**PDPLANPMTD-2024/046417**

**PROPOSAL:** Vehicle fuel sales & service (Service station), Storage (Four warehouses) & signage

**LOCATION:** 1106 Cambridge Road, Cambridge (with access over 1102 Cambridge Road and adjacent road reserve)

**FURTHER INFORMATION -  
PDPLANPMTD-2024/046417 - 1106 CAMBRIDGE ROAD, CAMBRIDGE (WITH  
ACCESS OVER 1102 CAMBRIDGE ROAD AND ADJACENT ROAD RESERVE)**

**1 PROPOSED SITE PLAN**  
 1 : 200

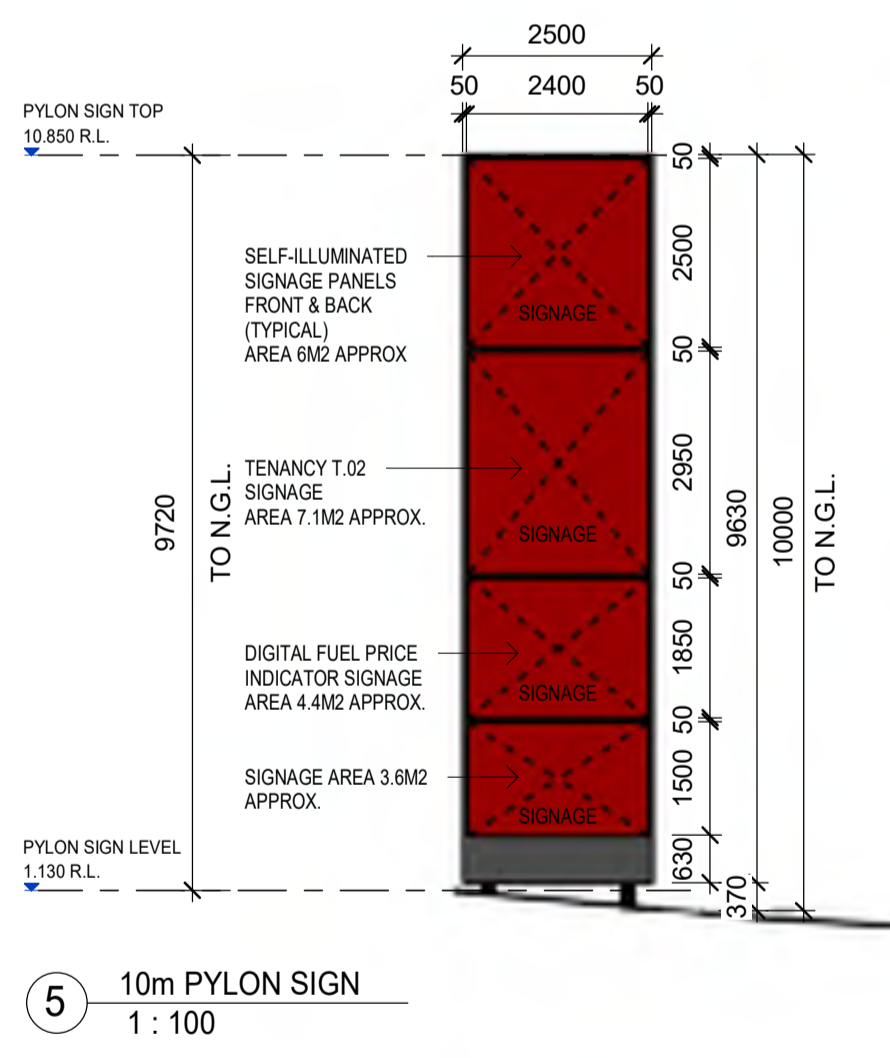
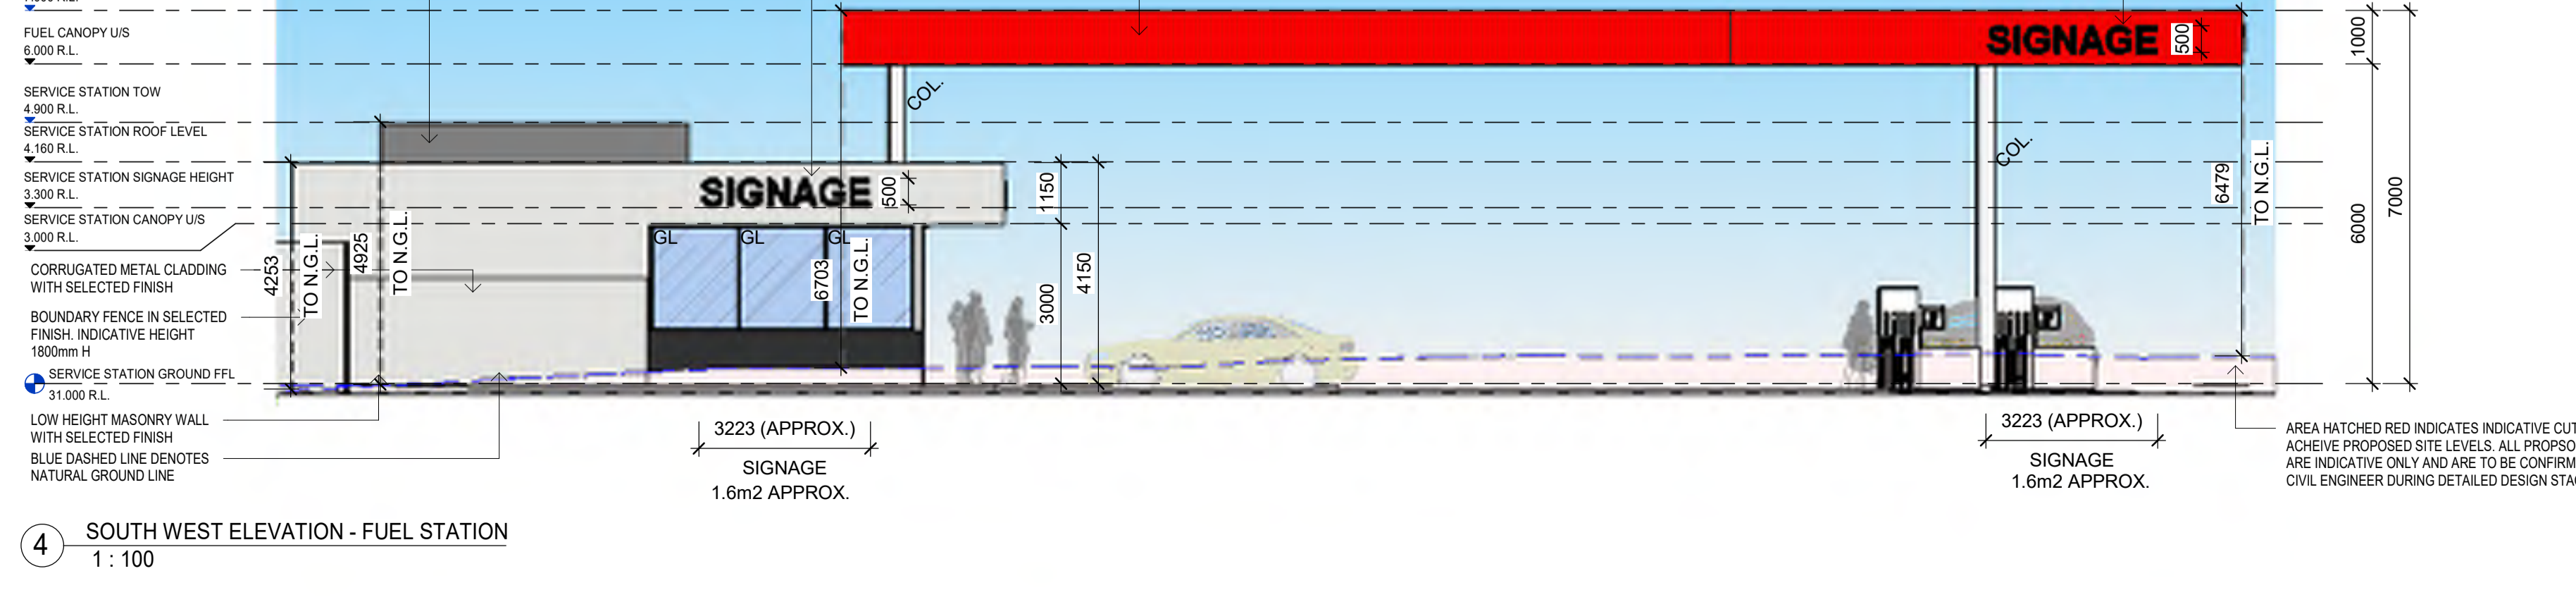
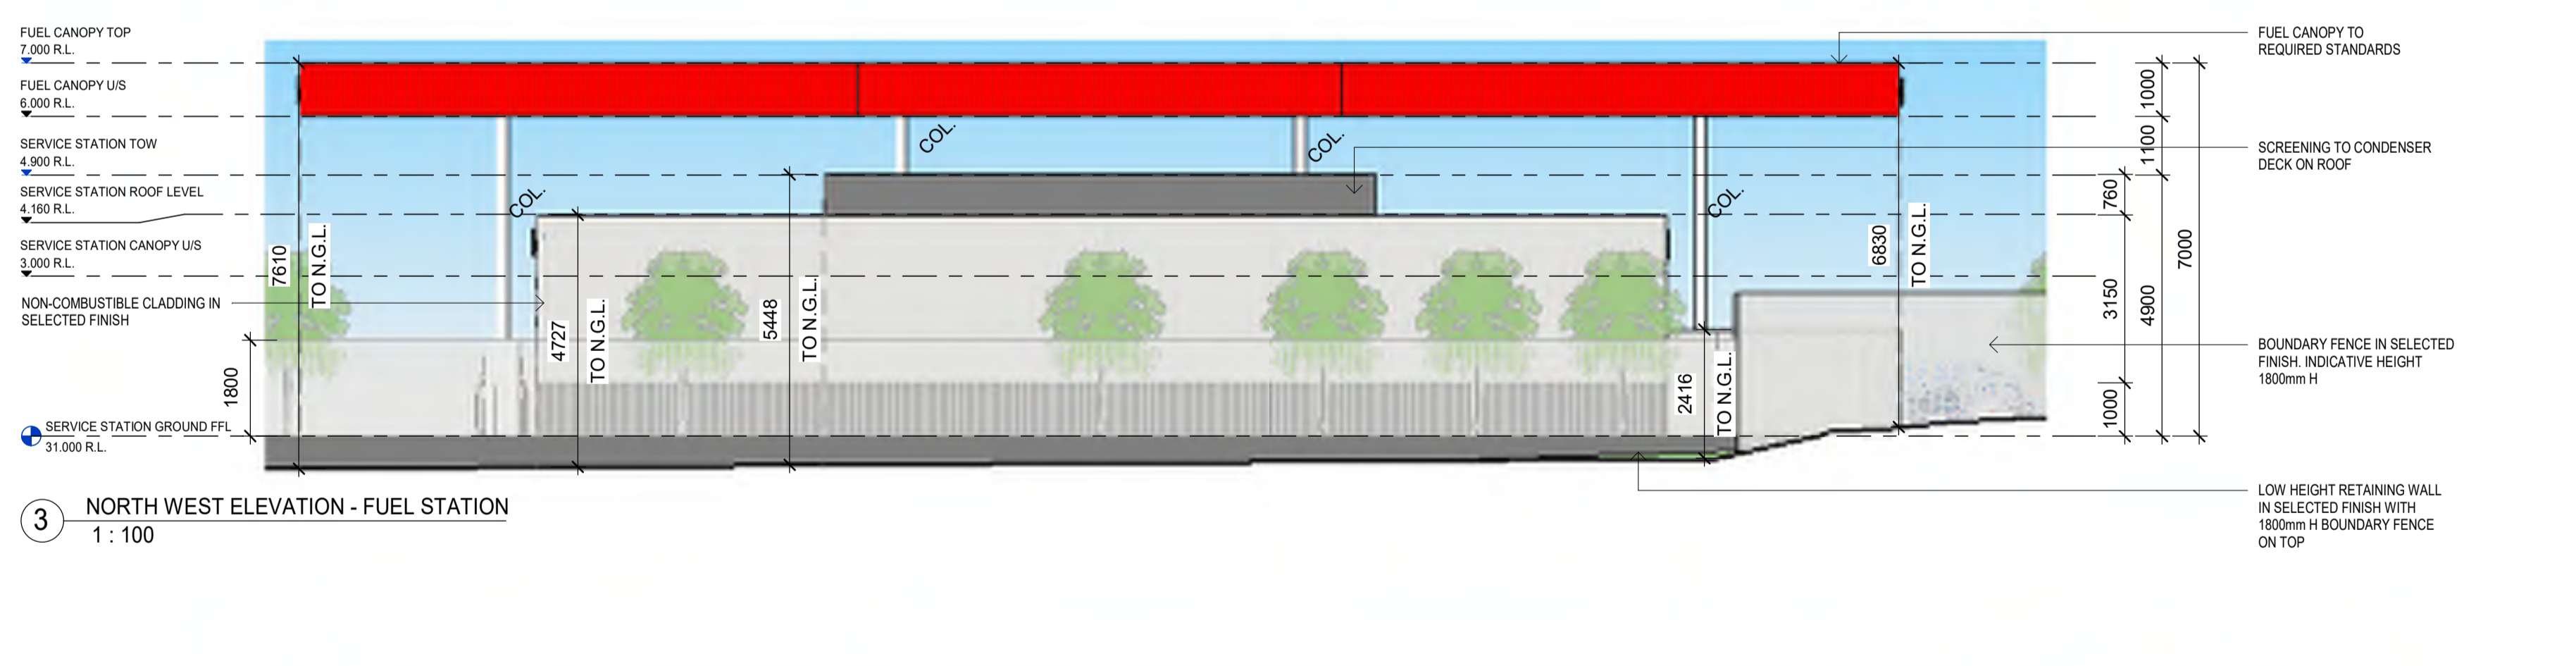
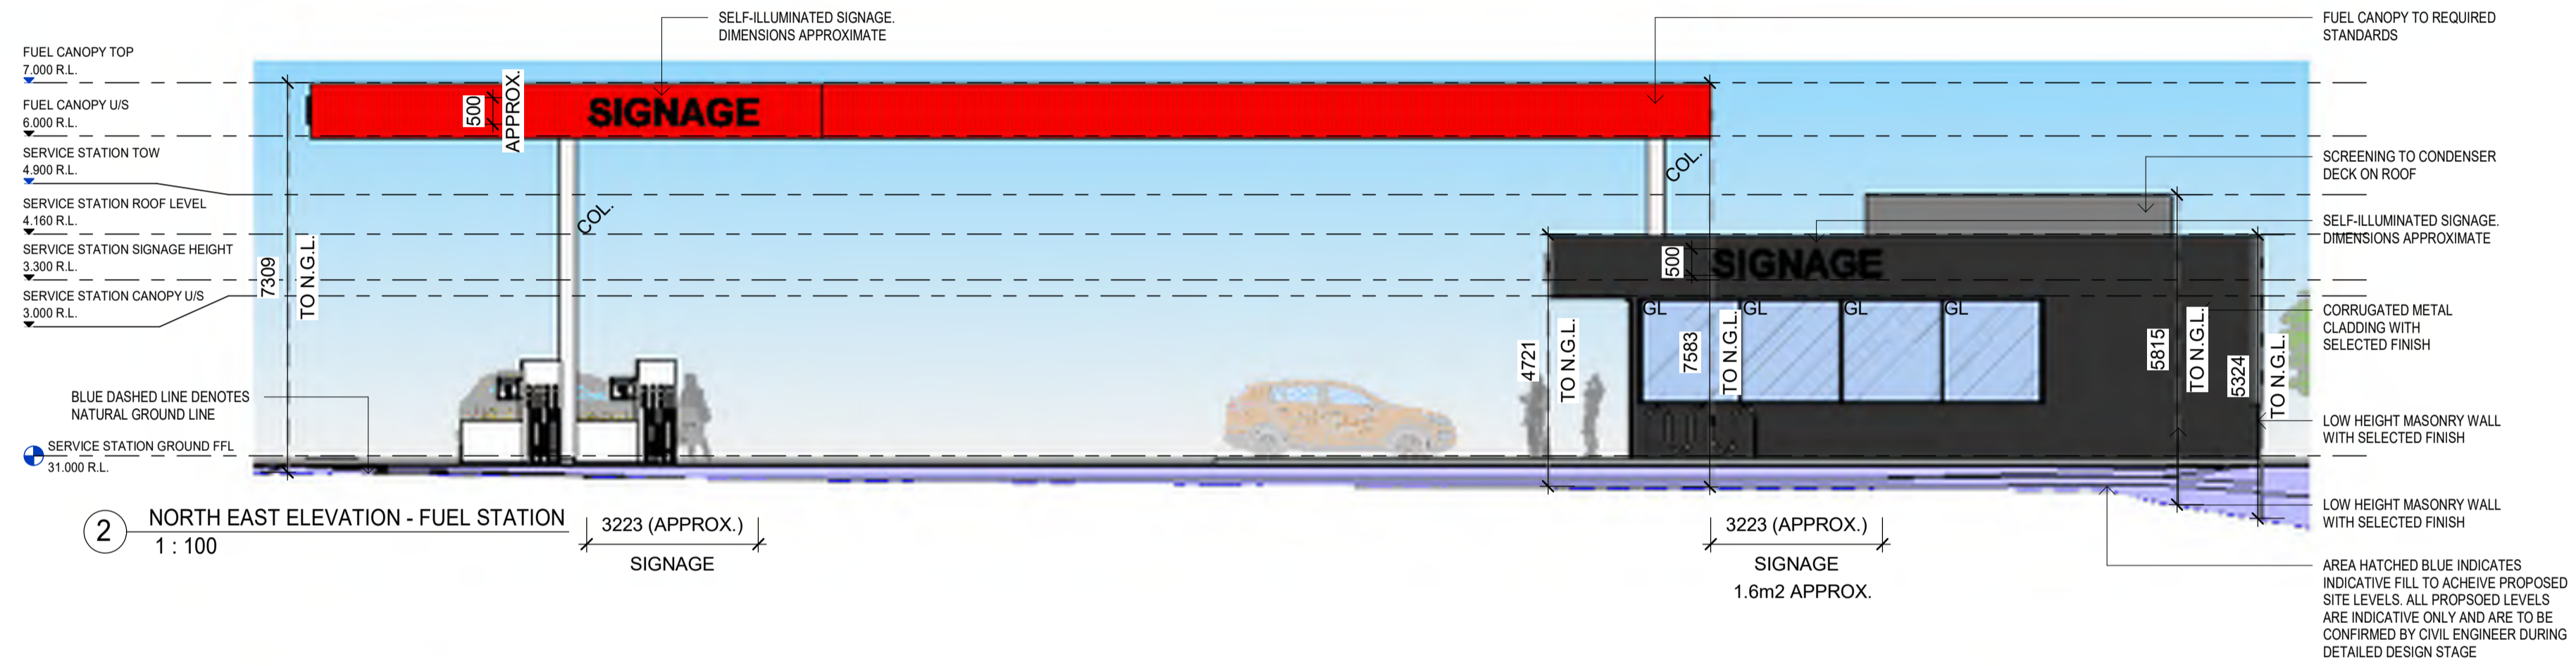
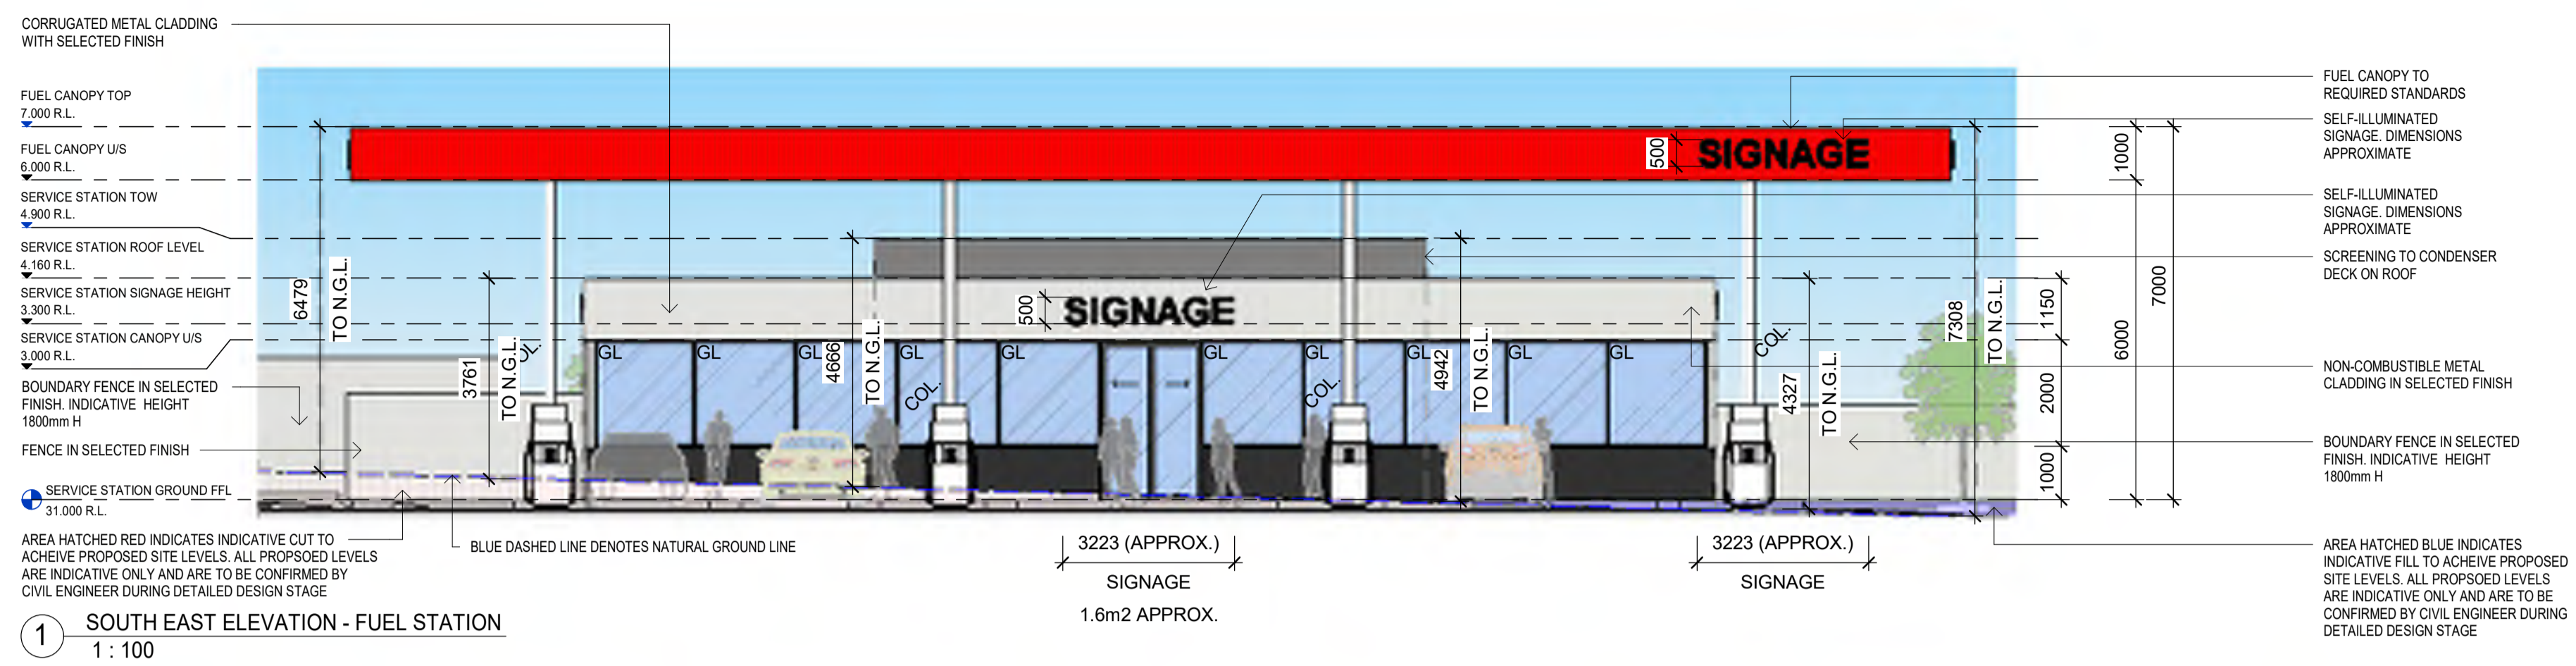
*• Please provide documentation to address the requirements of Clause C2.6.5 of the Tasmanian Planning Scheme - Clarence (the Scheme), specifically in that whilst the pedestrian connectivity from the shop to fuel sales area and parts of the storage area is recognised, an improved pedestrian arrangement is considered necessary to involve the balance of the storage use area and shared public path on Cambridge Road.*

Please refer to the amended site plan, which illustrates improved connectivity between the warehouse and fuel uses, extending through to the site frontage and linking directly to the road.
